**Ko'Kwel Wharf Improvements Project**  
**BID PACKAGE**  
**Addendum No. 2**  
July 17, 2025

**Ko'Kwel Wharf Improvements Project - BID PACKAGE**  
**Responses to Questions**  
July 17, 2025

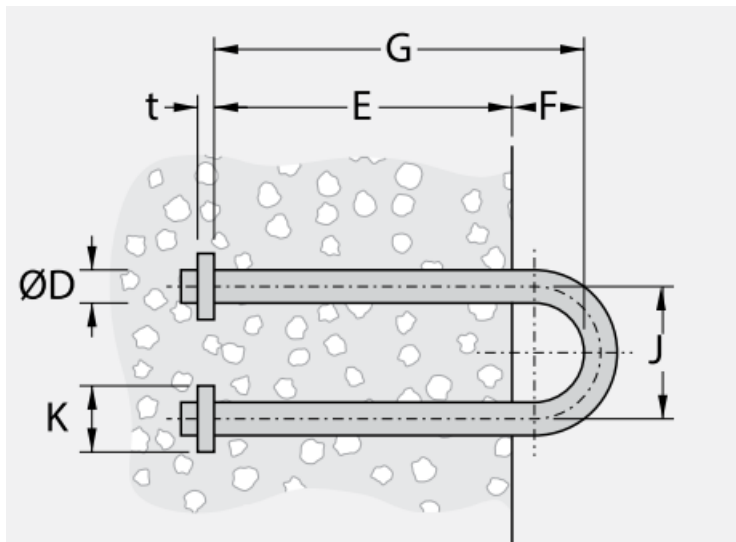
**Question 58.** Part of your answer to question 29 was that the U-Anchors shall be a 1" dia. cast-in U-Anchor, galvanized. I'm assuming the diameter of the anchor will be 1". What is the spacing of the two legs? What are the lengths of the legs? How much thread is required on each leg? Will there be a plate across the two legs that gets embedded in the concrete? If so, what are the dimensions of the plate?

**Response 58.** The intent is to use a commercially available U-Anchor similar to shown below. Dimensions may vary slightly based on manufacturer. For a 1" dia. cast-in U-anchor. Typical dimensions are E = 10", F = 2.5", G = 12.5", J = 4", K = 2" and t = ½". If the contractor would like to fabricate the anchors, details may be provided during construction.

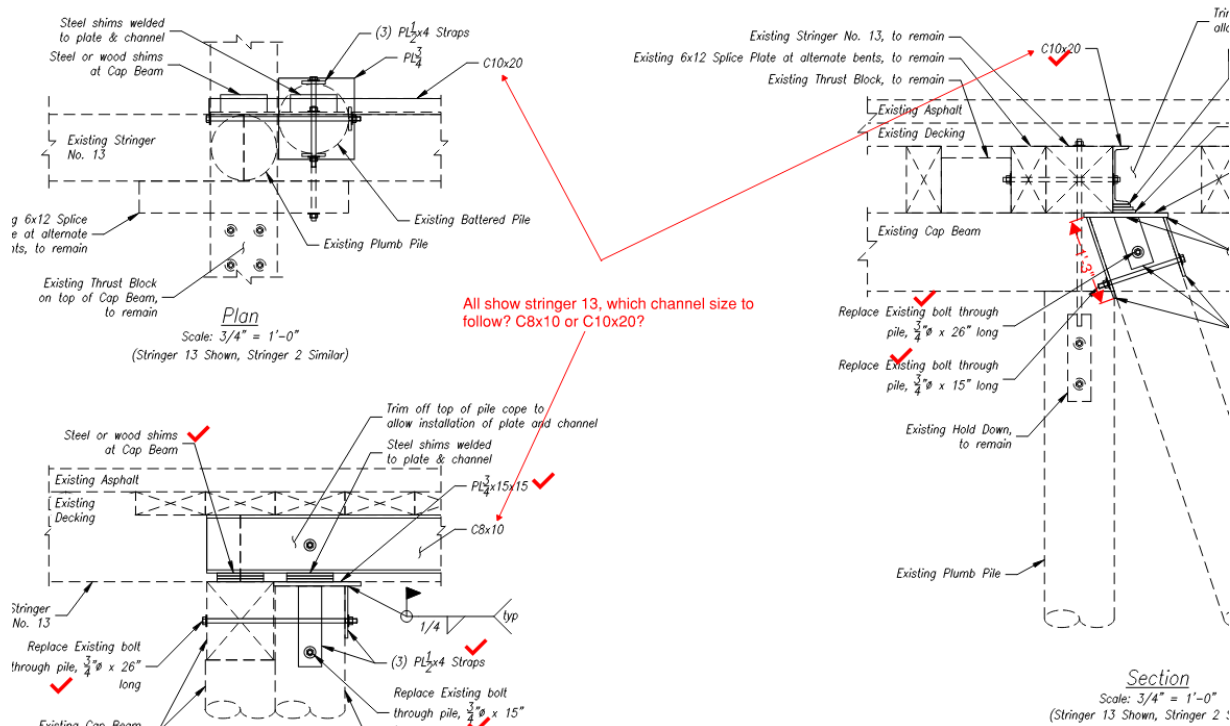
**Question 69.** The figure below shows stringer 13, please advise as to the correct sizing of the C-Channel?

**Response 69.** Channel shall be C10x20.

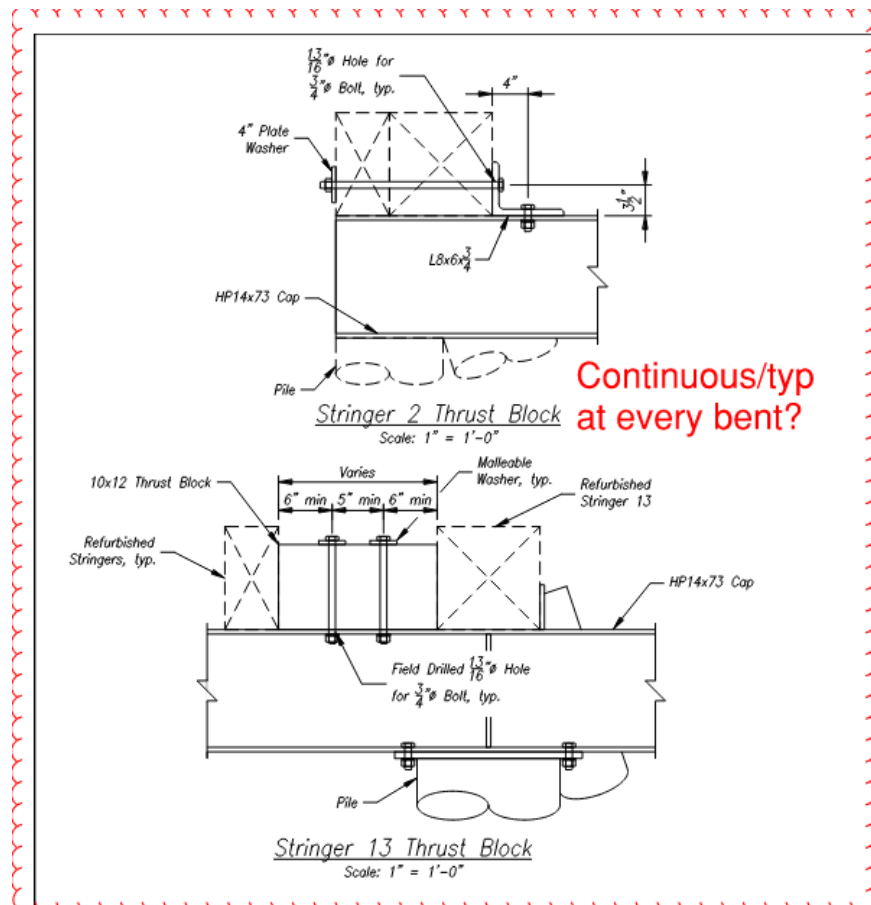
**Question 70.** The figure below shows the stringer thrust blocks, please advise as whether the thrust blocks are continuous or typical from bent to bent.

**Response 70.** The L8x6x3/4 and 10x12 Thrust Blocks are typical, bent to bent. The refurbished stringers are continuous. See Section Views on Sheet 80.
